MEMORANDUM

Subject: Addendum to MovingAhead Alternatives Analysis Technical Reports

This document is an addendum to the MovingAhead Project's Alternatives Analysis (AA) Draft Final Technical Reports, dated May 2017. This addendum serves to provide new options for mitigating potential adverse effects as related to the information gathered by the AA Technical Reports.

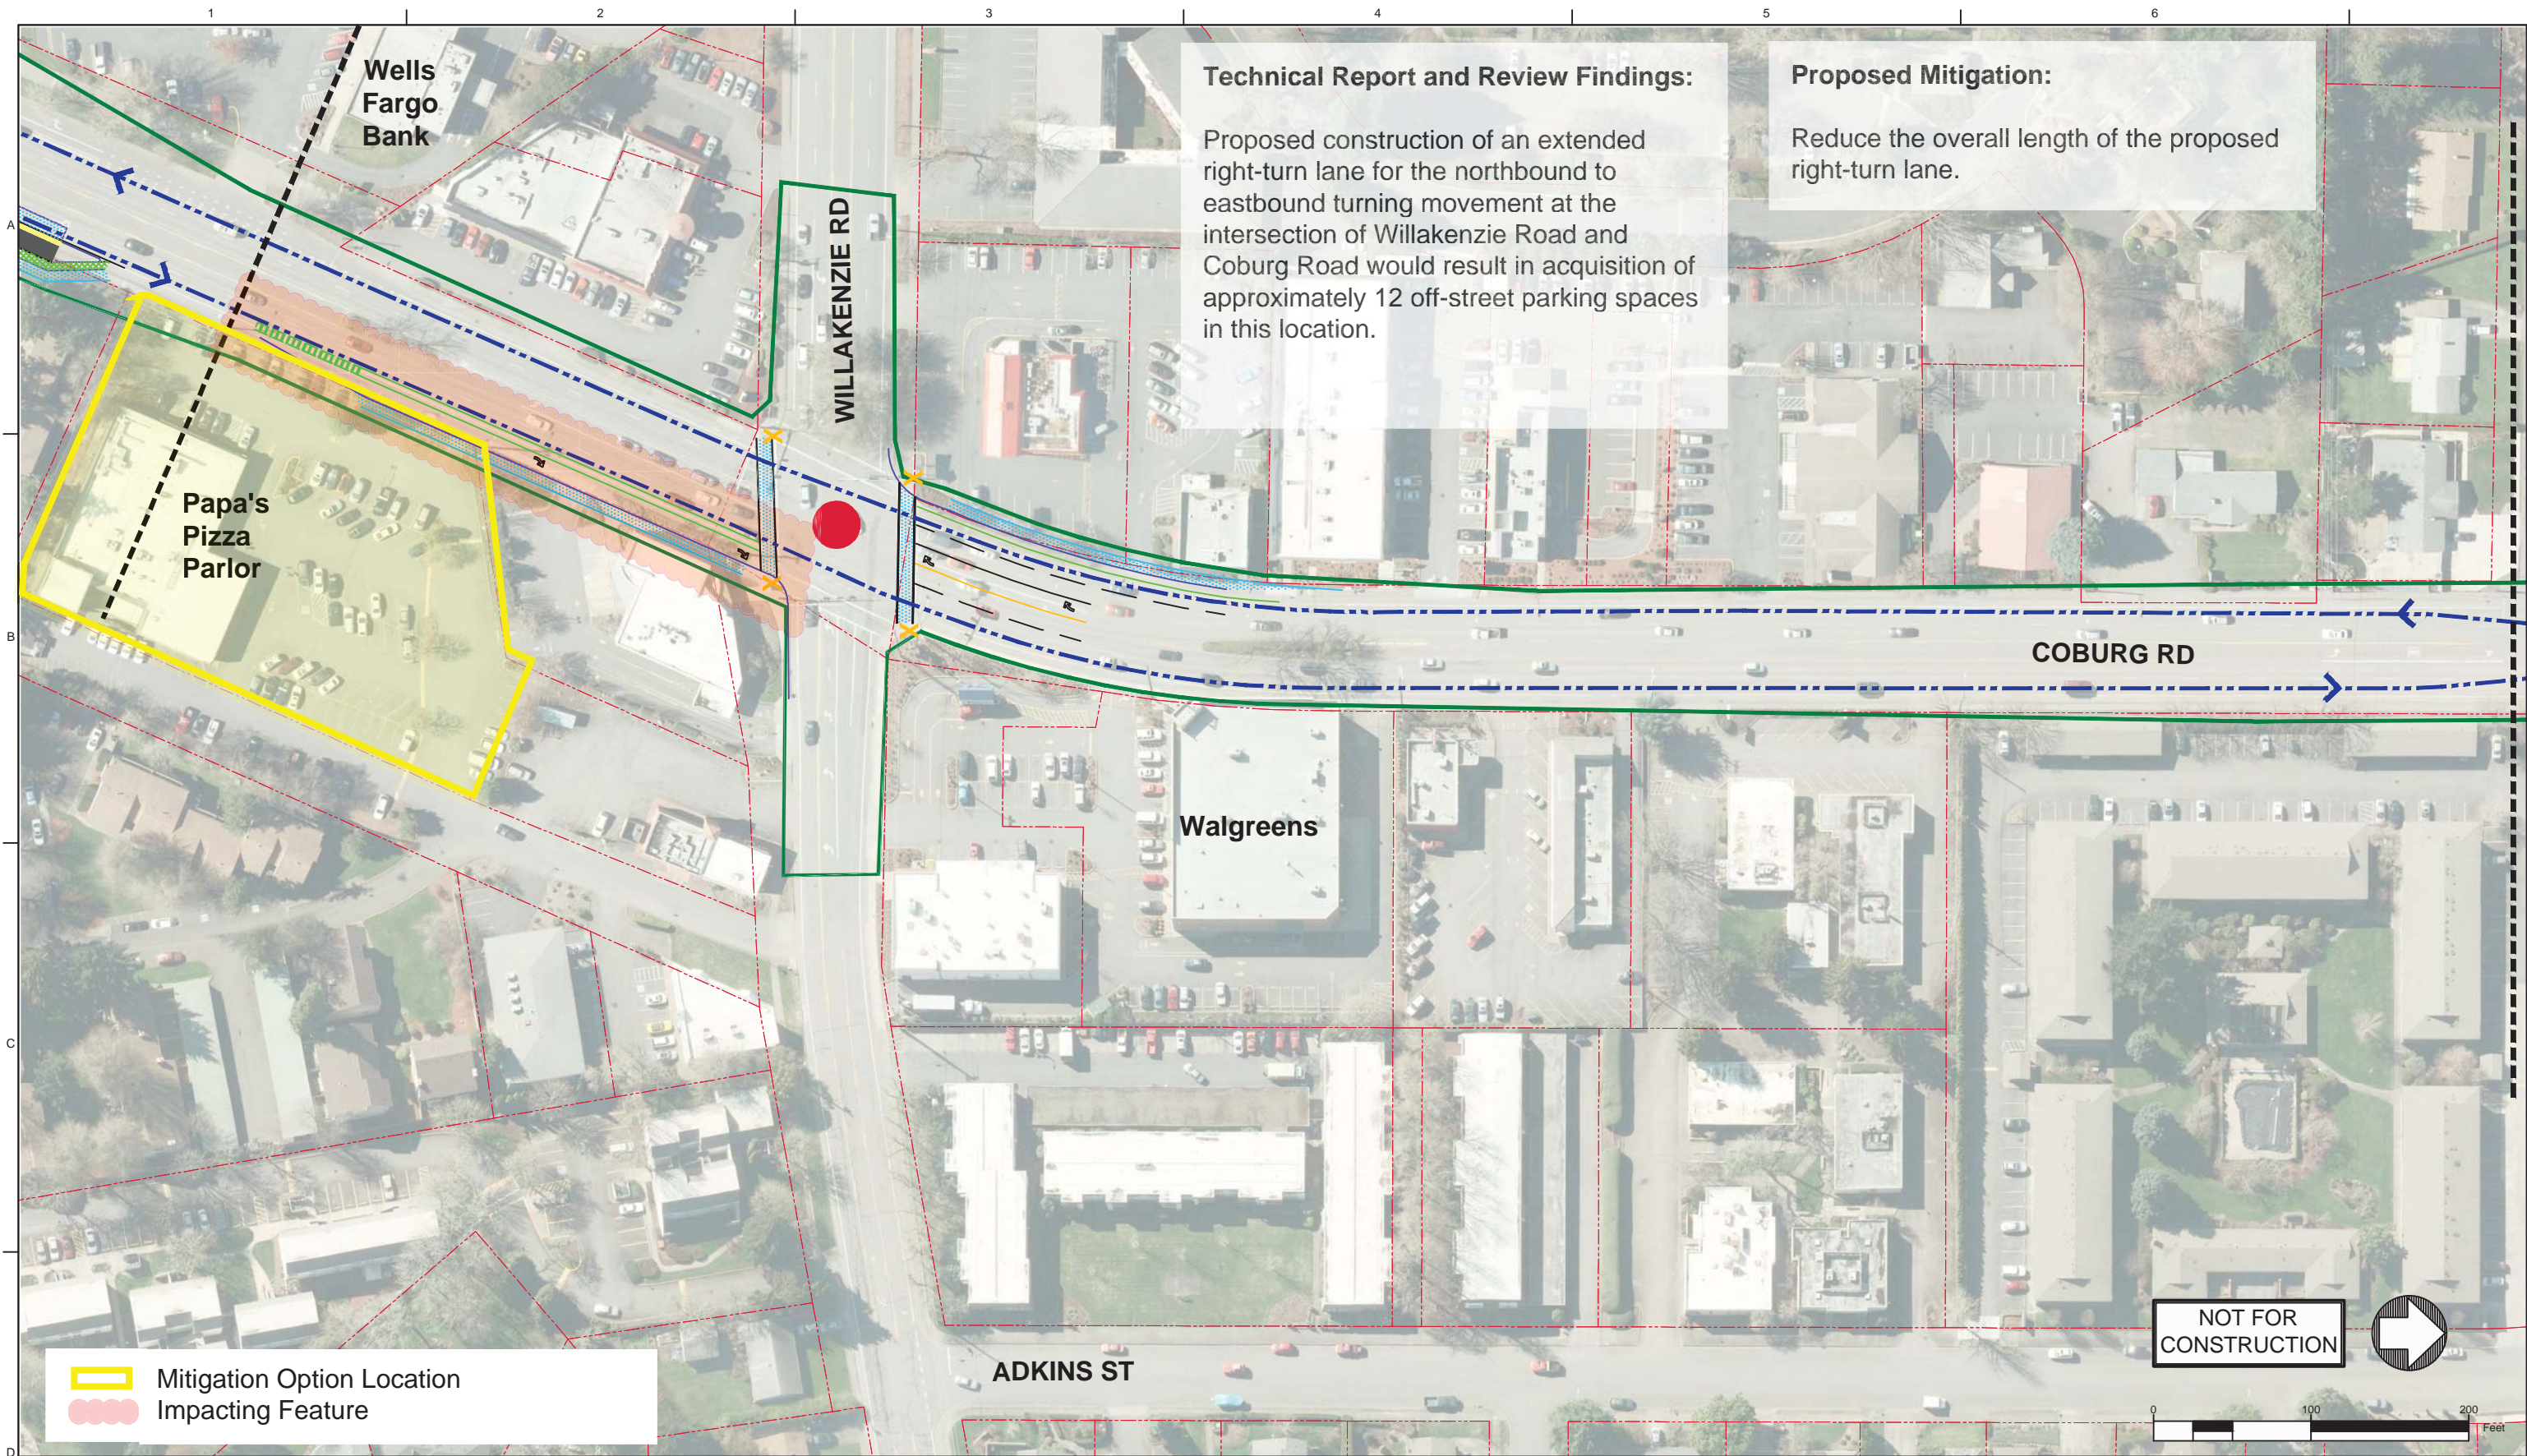
Proposed construction of an extended right-turn lane for the northbound to eastbound turning movement at the intersection of Willakenzie Road and Coburg Road would result in acquisition of approximately 12 off-street parking spaces in this location.
